1991 Corvette: Service Bulletin: Squeak and Rattle Diagnosis Guide

Subject: SQUEAK AND RATTLE DIAG. GUIDE DIAGNOSTIC AID/CORRECTION

Model and Year: 1991 CORVETTE

Bulletin Number: 91-264-10 - (03/25/1991)

FIGURE 1

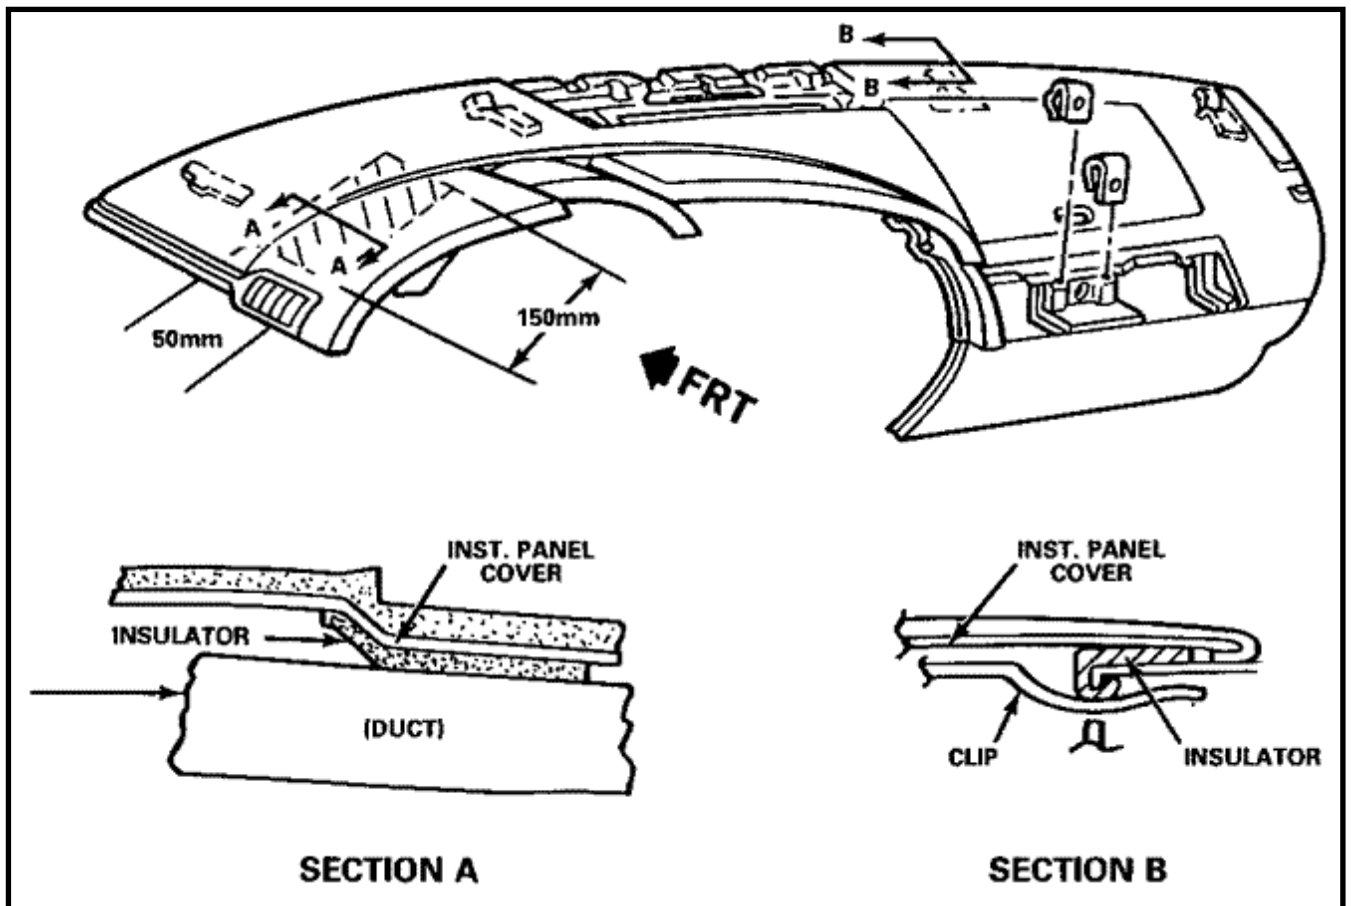
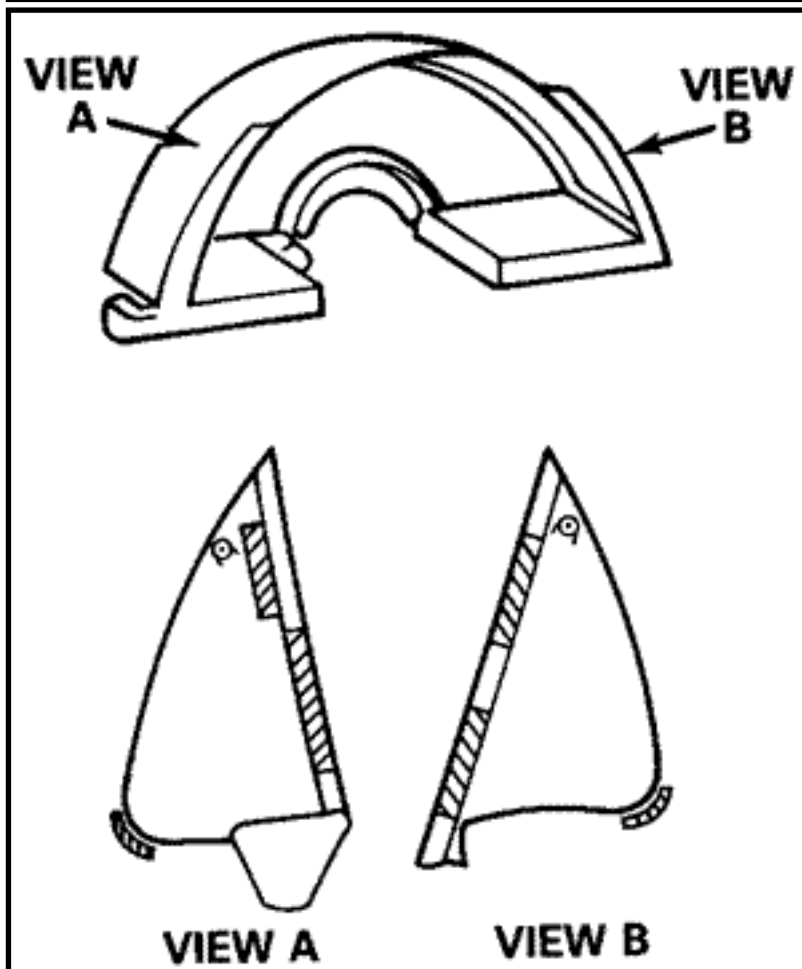
1. Rattle forward of gages cluster 1. Insulate area shown in Figure at A/C cross car duct. 1 and Figure 1, Section A (felt material).

2. Rattle at front edge of cover 2. Reposition existing, or near windshield. install felt insulators on metal opening at all retainers, (see Figure 1, Section B). - Left defogger outlet

FIGURE 3

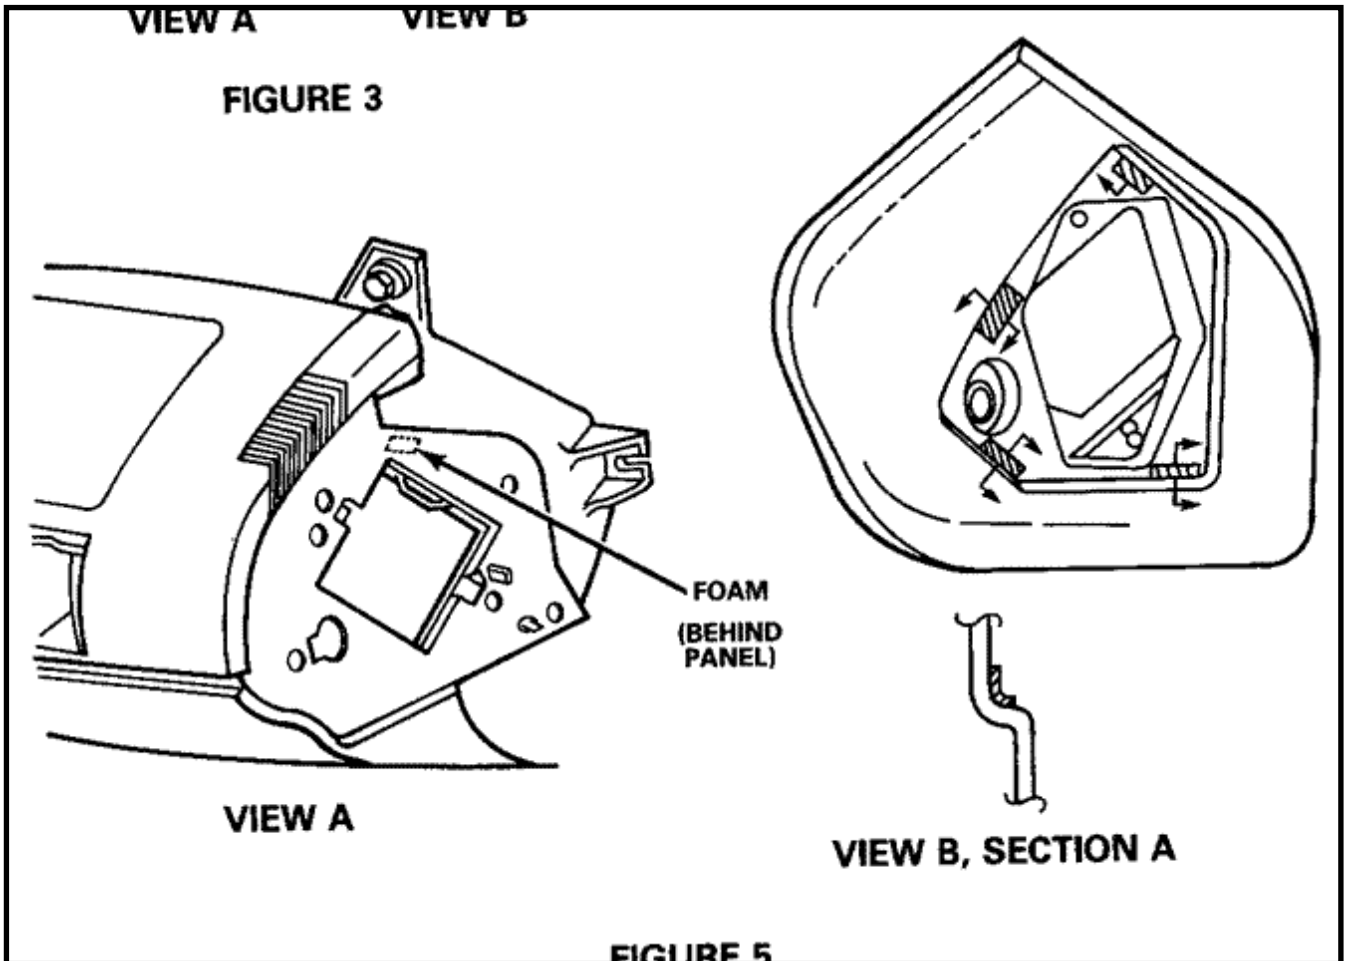
1. Squeak in instrument cluster 1. Apply felt insulators to bezel to cover. bezel edges and surfaces in locations as shown in Figure 3, views A and B.

FIGURE 5

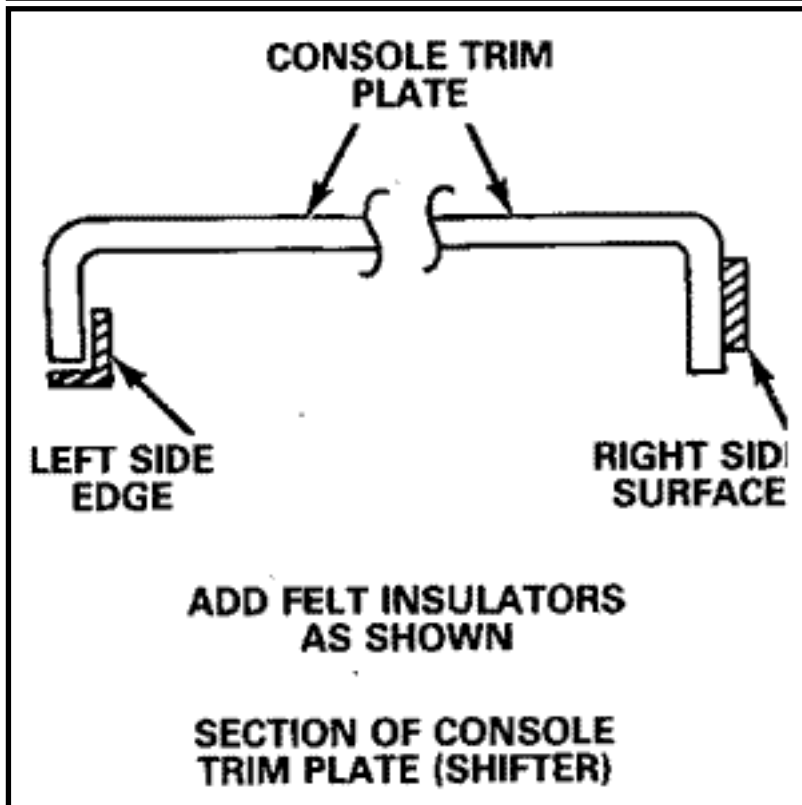
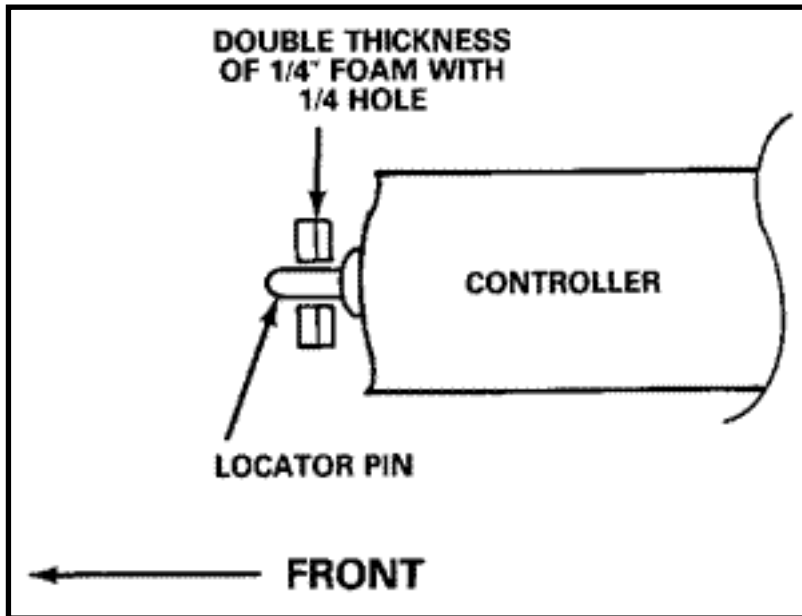
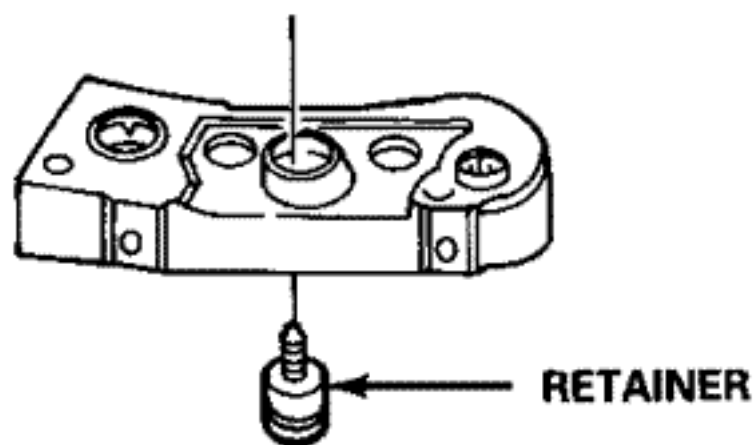
2. Buzzing of fuse box rivet 2. Apply small 1/4" foam heads to instrument panel insulator between rivet head cover. and cover as shown and cover as shown in Figure 5, view A.

3. Buzzing of fuse box door 3. Apply felt insulators (1/4" X in the opening. 1") as shown in Figure 5, view B. Position felt into the radius of the opening.

**REMOVABLE ROOF, FRONT
BOLT AND RETAINER**

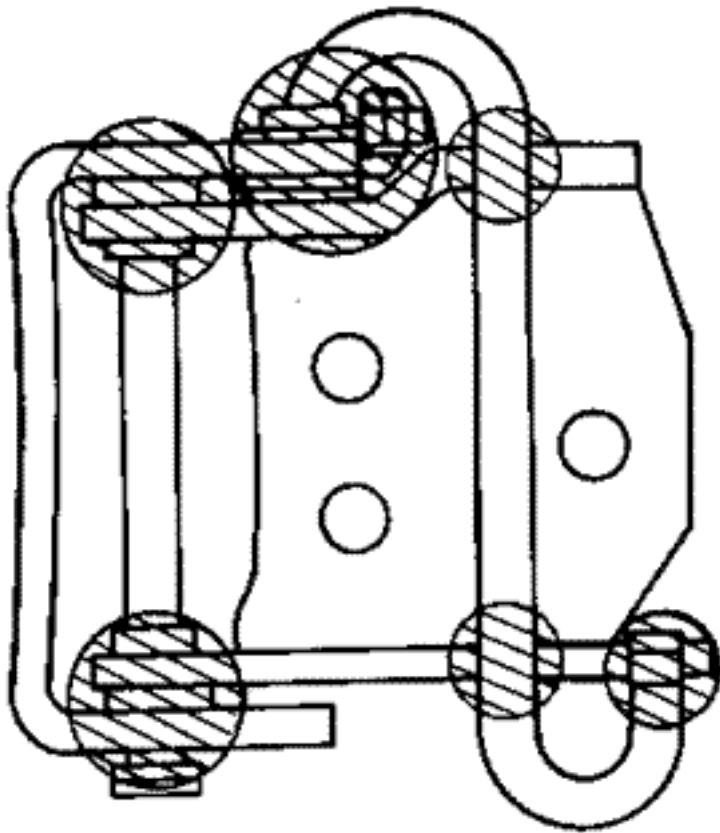
1. Rattle of front attaching bolts 1. Install new bolt retainers, when panel is stowed in rear. P/N 10 1 75804, see Figure 8.

1. Soak new retainers in warm water to aid in installation.
2. Remove roof panel and stow.
3. Remove upper trim covers at right and left latch areas.
4. Remove right and left sun visors, inside mirror and center garnish molding.
5. Carefully pry original retainer and bolt out of housing using a flat blade screwdriver or other suitable tool.
6. Install bolt in new retainer, align locating rib on retainer with notch in housing and press into place with a "C" clamp and socket.
7. Reinstall garnish molding, inside mirror, sun visors and upper trim covers.

- **PRY BOLT & RETAINER OUT
OF HOUSING WITH FLAT
BLADED SCREWDRIVER**
- **ALIGN LOCATING RIB WITH
NOTCH IN HOUSING**
- **PRESS INTO PLACE WITH
'C' CLAMP**

**LUBE AT SHADED AREAS
DOOR UPPER HINGE**

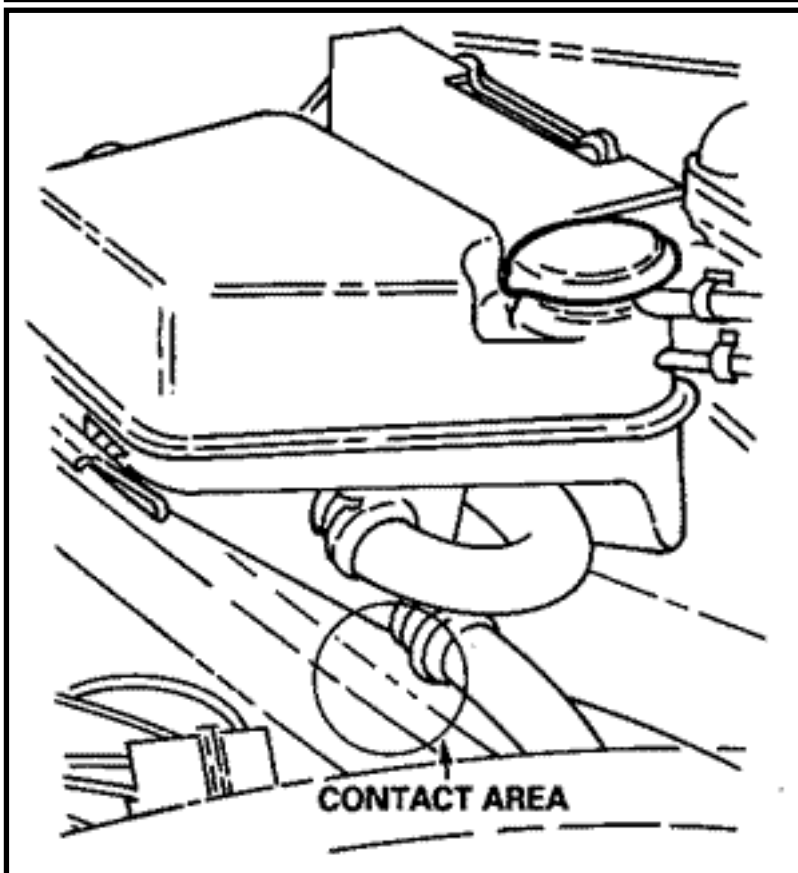
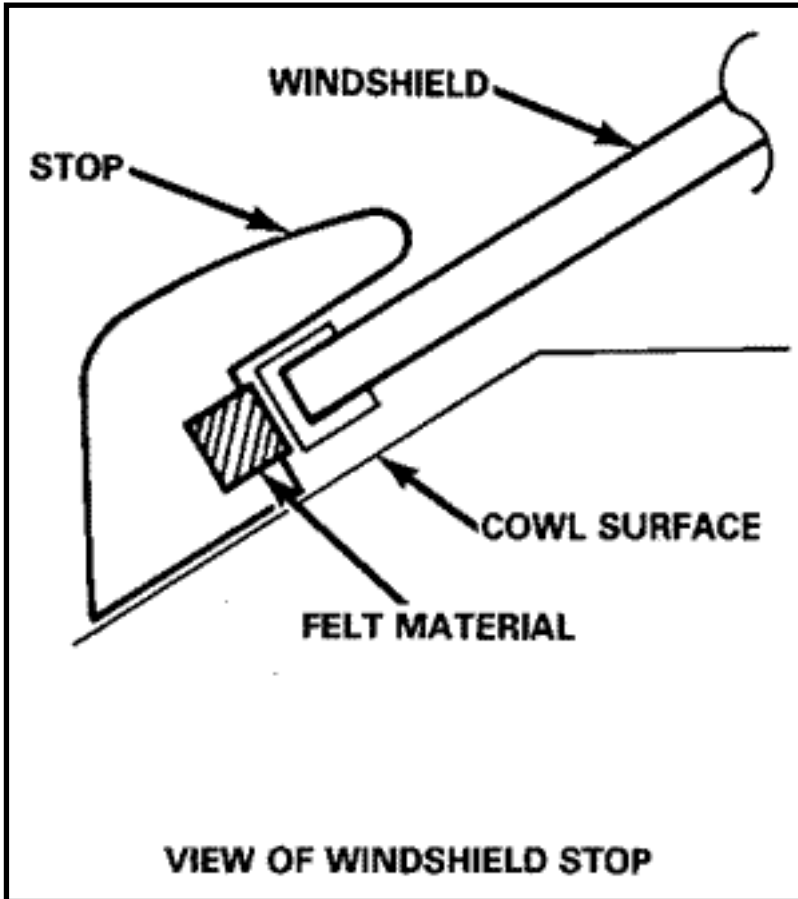
1. Squeaks when opening doors at 1. Lubricate ALL hinge torque hinge torque rod contact areas. rod contact areas with 30 wt. motor oil or grease, see Figure 9. UNDER THE HOOD ----- COMPONENT
